ADDENDUM NO. 1

RED CLAY CONSOLIDATED SCHOOL DISTRICT
WILMINGTON CAMPUS RENOVATIONS
BID PACKAGE 'B'

This addendum is hereby made part of the Project Manual and Drawings dated 28 May 2013.

SHEET TITLE
PARTITION SCHEDULE

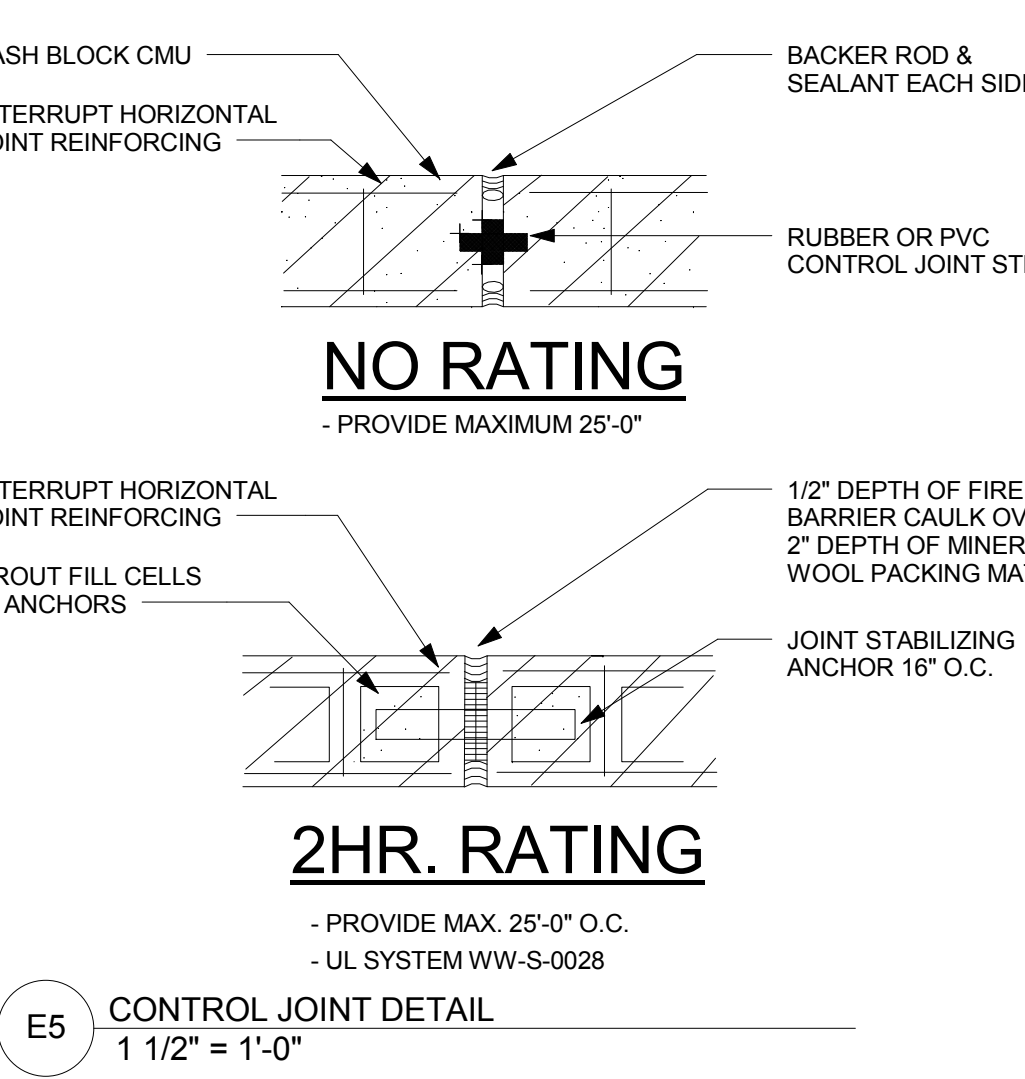
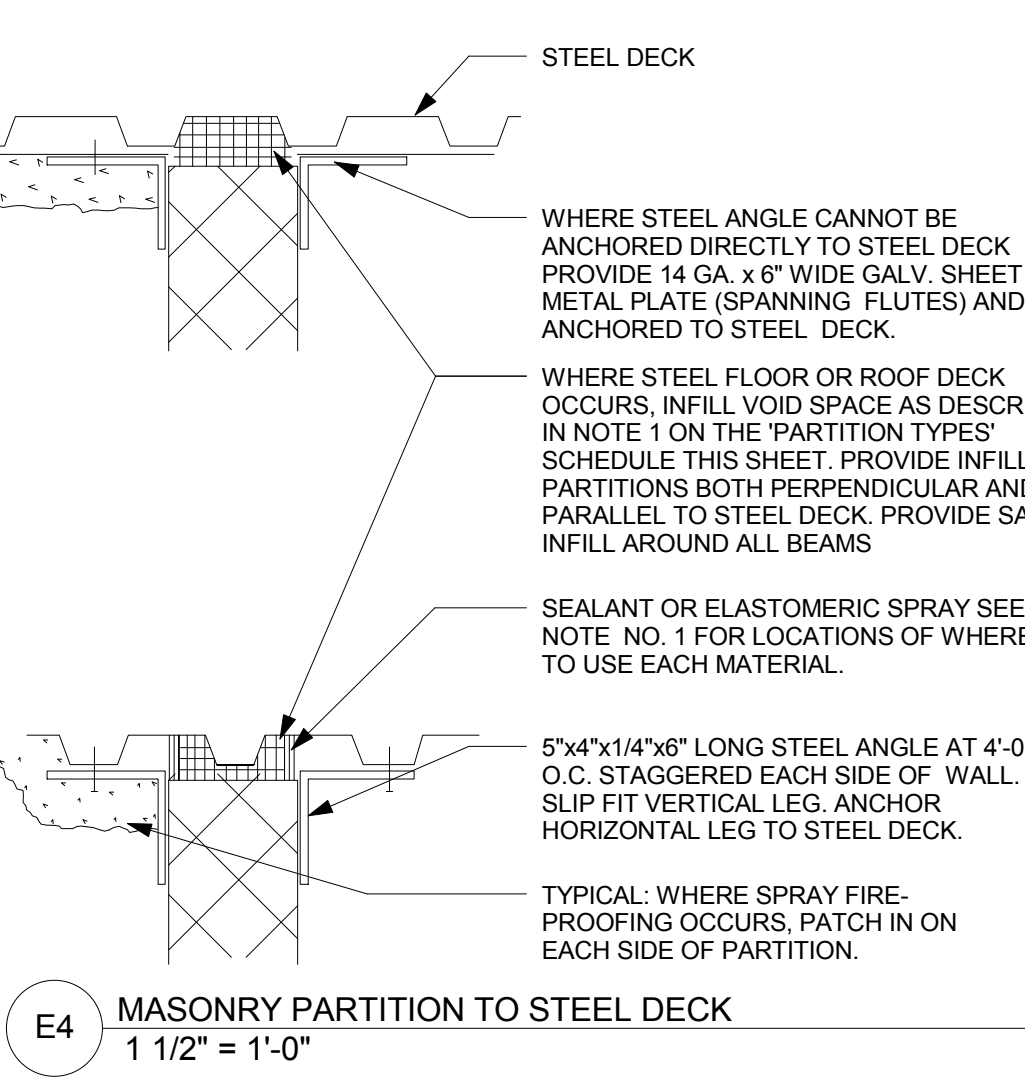
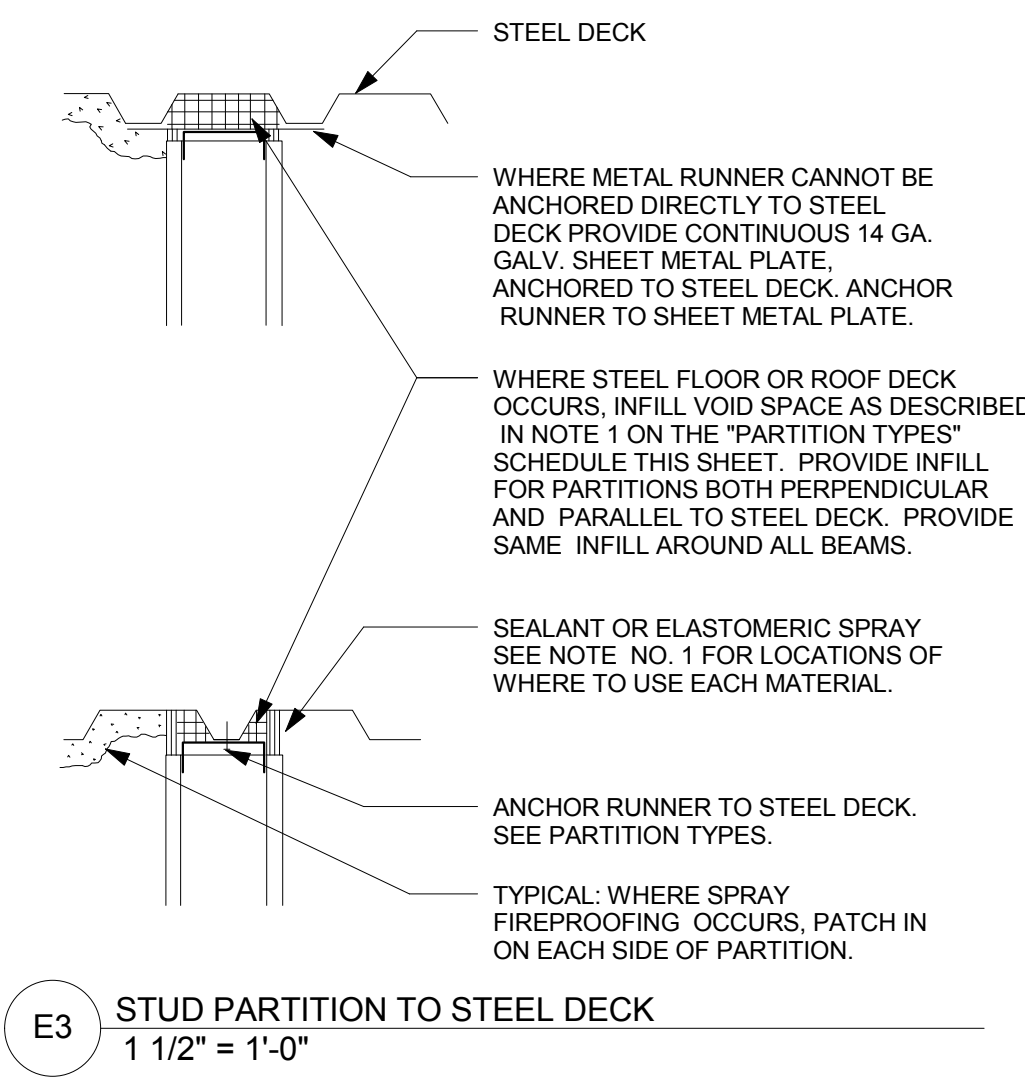
A. A-002 PARTITION SCHEDULE: REPLACE drawing in its entirety with attached drawing annotated Addendum No. 1, dated 06/07/13.

G5 PARTITION TYPE
EXTEND TO UNDERSIDE OF DECK

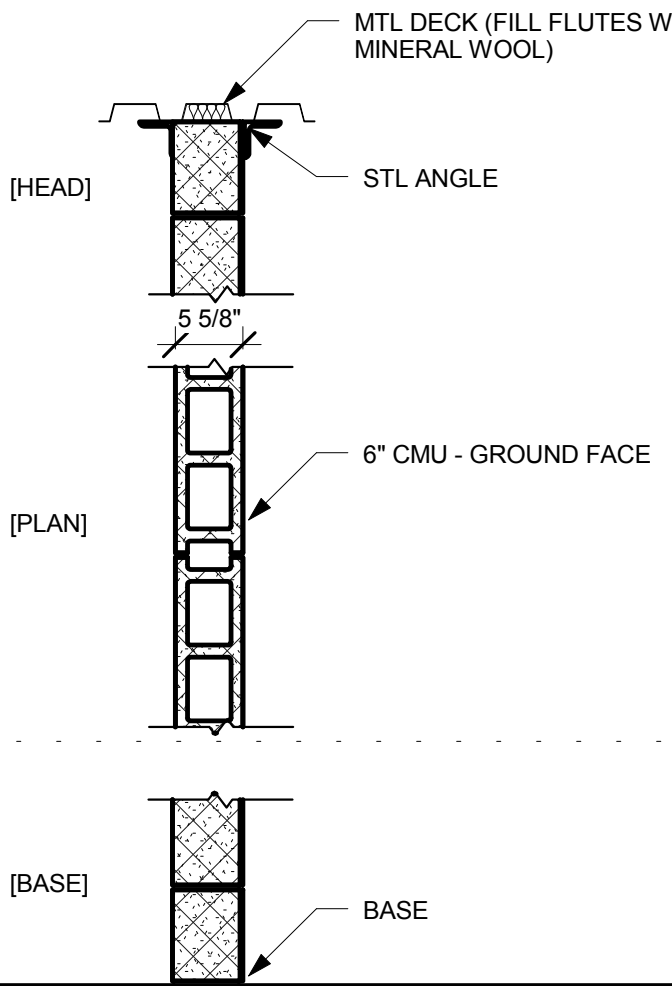
B. A-112 MEZZANINE: Change partition tags “G3” & “G4” to “G5”.

REFERENCE DWG M-111
ADDENDUM #1

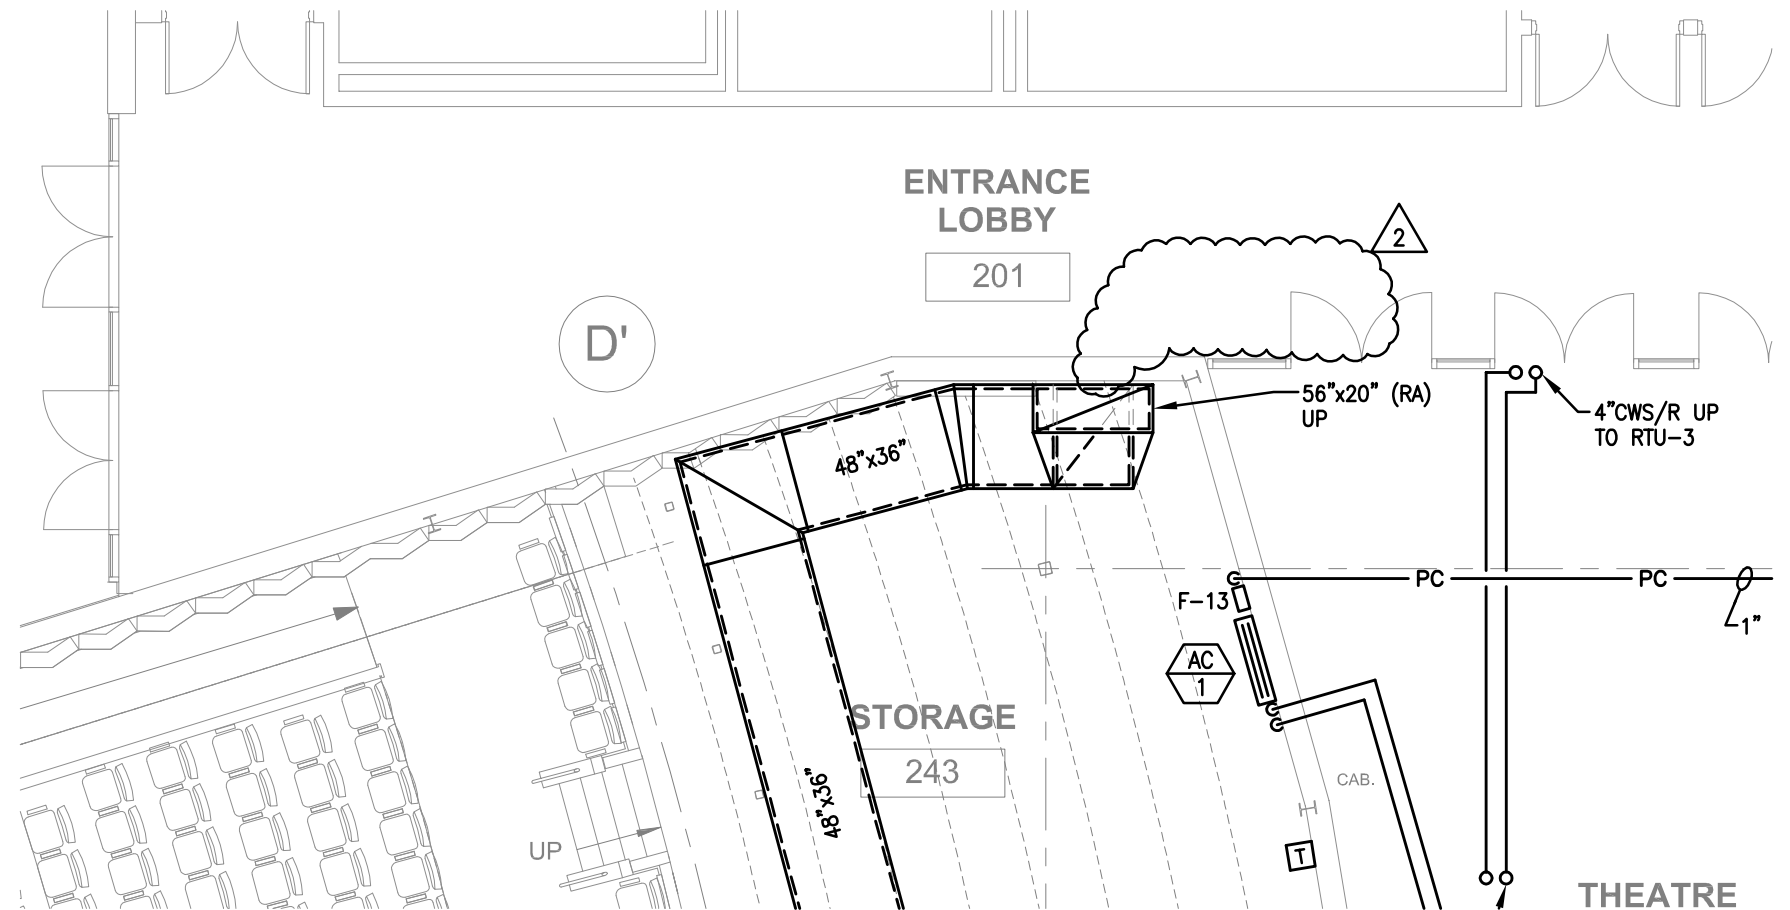
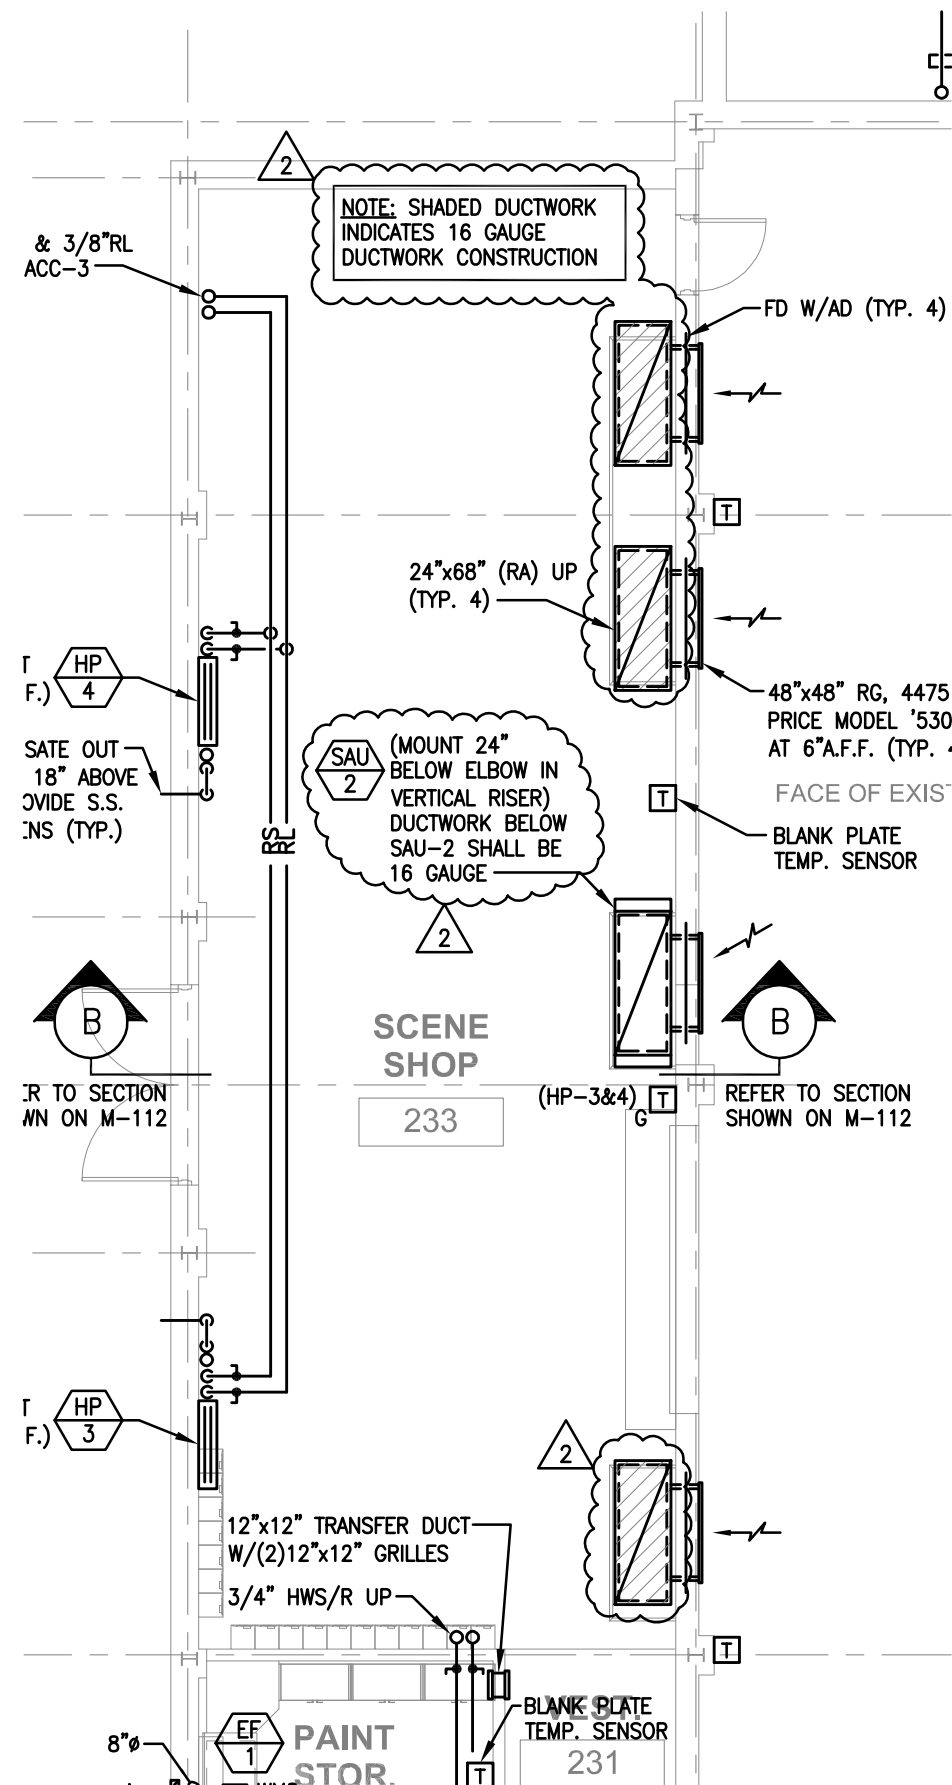
C. M-111 SECOND FLOOR MECHANICAL PLANS:

1. Remove SAU-7 from the vertical duct. Refer to sketch M-700.
2. Relocate SAU-2 to 24” below elbow. Refer to sketch M-700.
3. Add note and indicate location of ductwork to be 16 gauge construction. Refer to sketch M-700.

SHEET TITLE	
MEZZANINE MECHANICAL PLANS	
PROJECT	
WILMINGTON CAMPUS RENOVATIONS	
CONSULTANT	FURLOW ASSOCIATES, INC.
	MECHANICAL/ELECTRICAL ENGINEERS
<div style="border: 2px solid black; padding: 5px; font-weight: bold; font-size: 1.5em;">M-701</div>

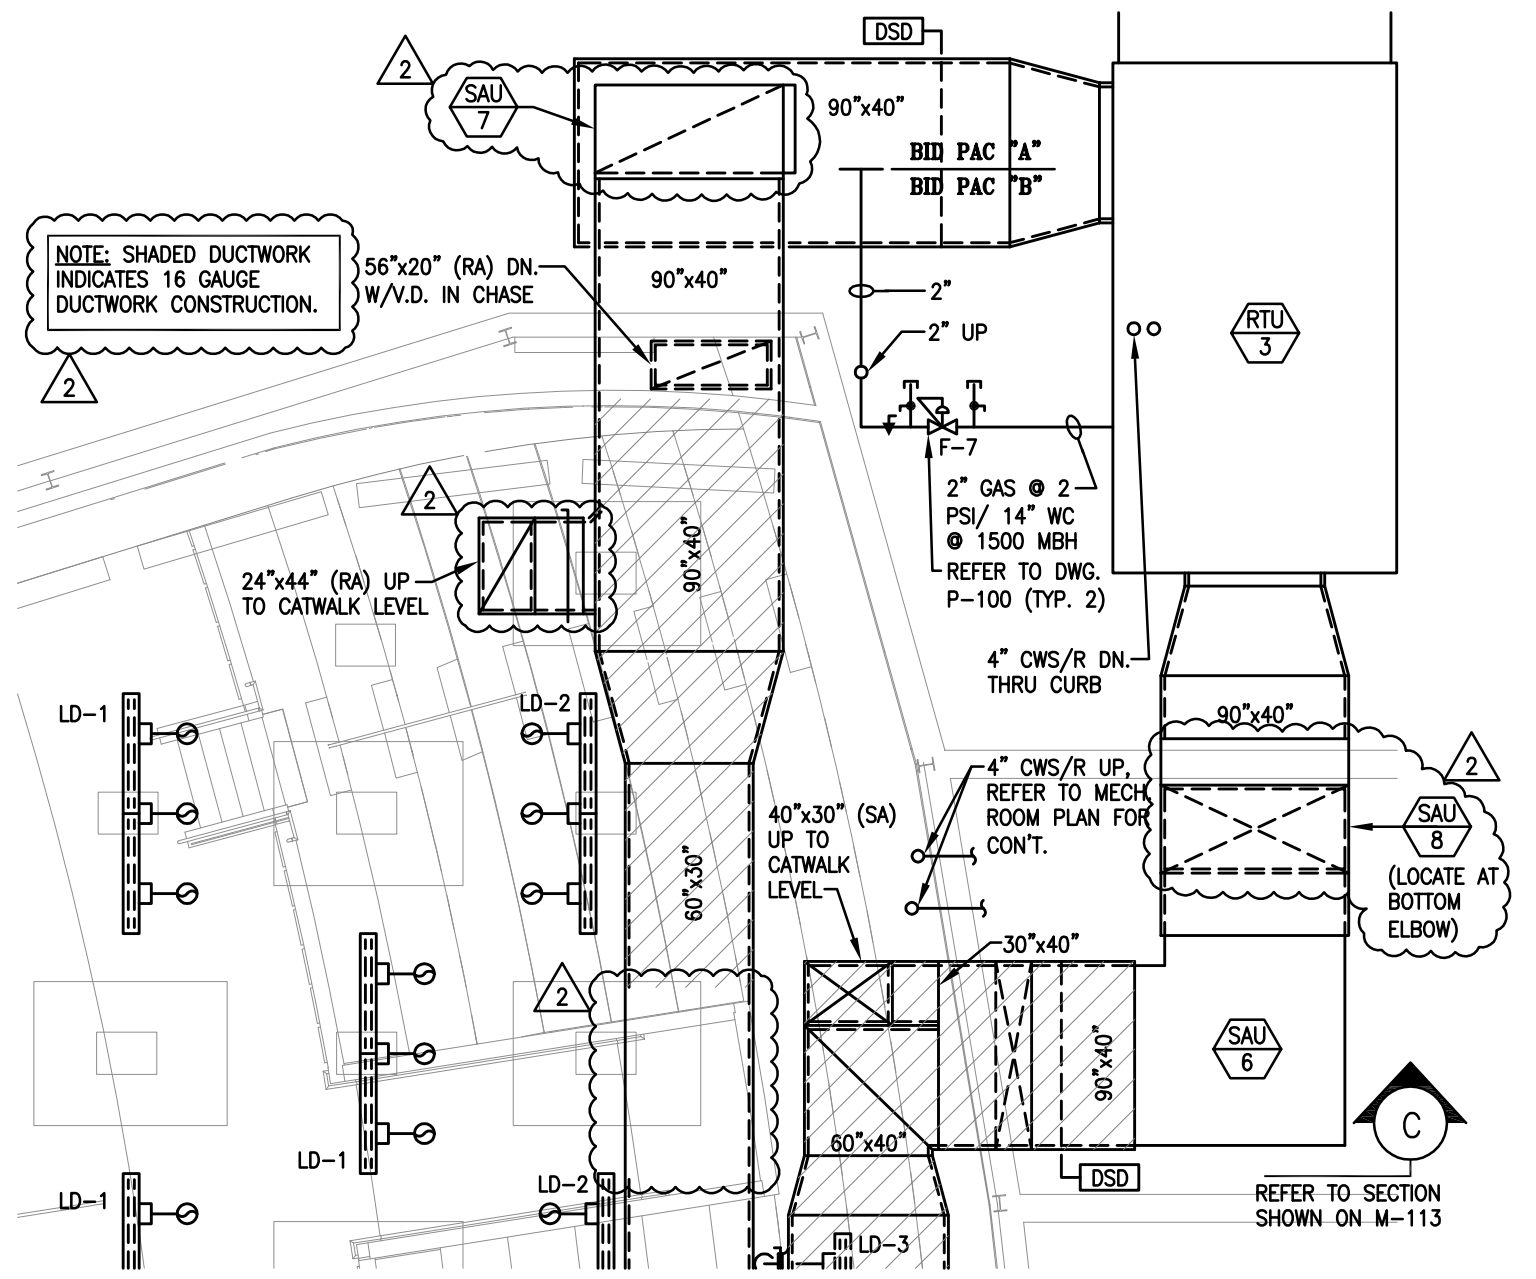
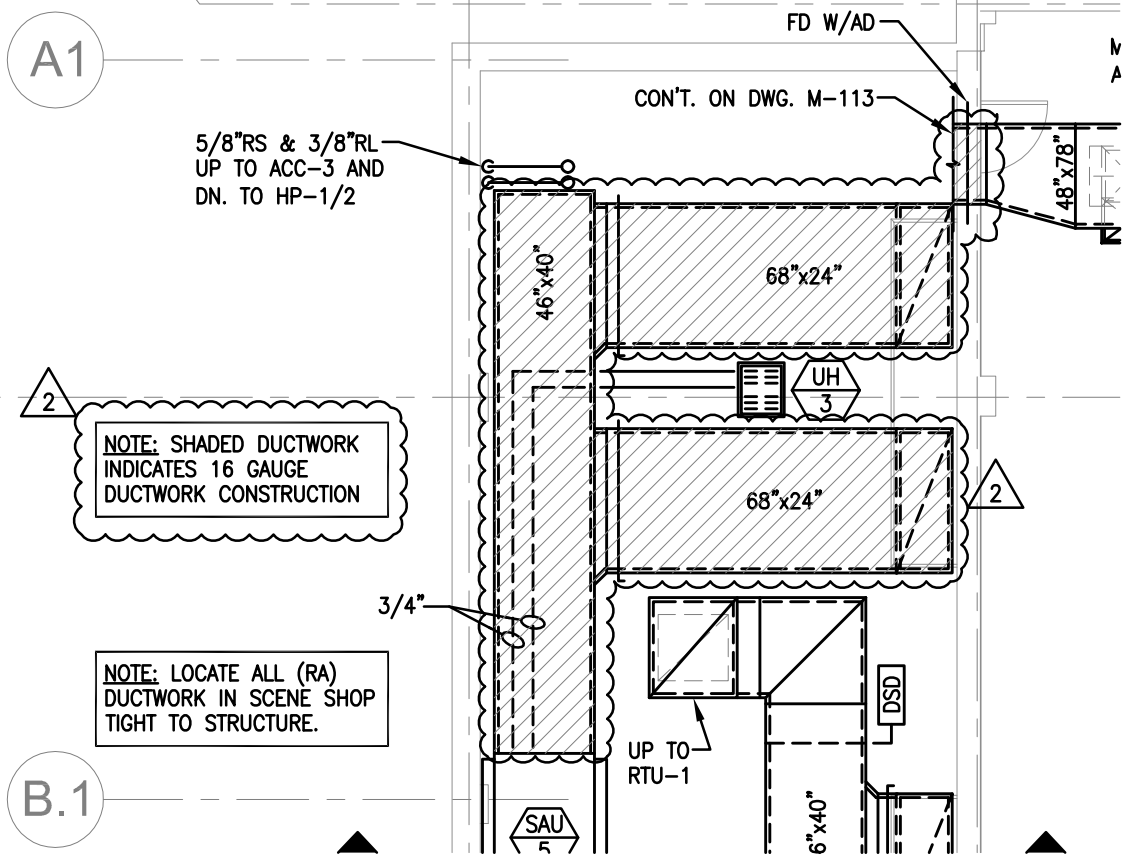
D. M-112 MEZZANINE MECHANICAL PLANS:

1. Relocate SAU-2 to 24” below elbow. Refer to sketch M-701.
2. Remove SAU-9 from return duct of RTU-3. Refer to sketch M-701.
3. Add SAU-7 to elbow of return duct for RTU-3. Refer to sketch M-701.
4. Add SAU-8 to elbow of supply duct for RTU-3. Refer to sketch M-701.
5. Revise note for shaded ductwork. Refer to sketch M-701.
6. Remove shading to 24”x44” (RA) duct. Refer to sketch M-701.
7. Add note and indicated location of ductwork to be 16 gauge construction. Refer to sketch M-701.
